FOREWORD

I found this document very hard to read. One problem is surely the fact that stressing genericity (oriented to non CCSDS compliant users) confuses the target of the *normal* use cases and hides reality.

64. Figure I-1 Random Sequence Generation

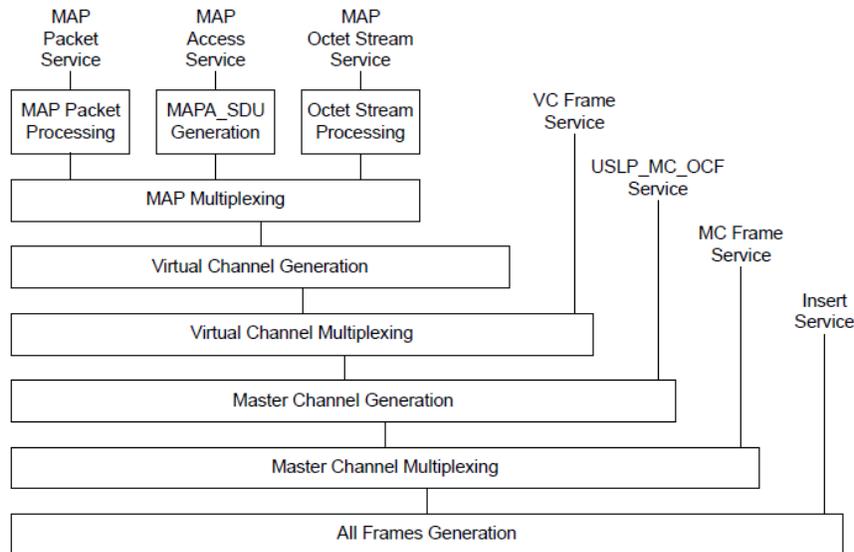
I would rename the box from “Random Sequence Generation” to “Randomization” or “Transfer Frame Randomization” this would avoid the strange xor beneath the box and would make more sense for the output being “(Randomized) Transfer Frames” (as shown in figure)
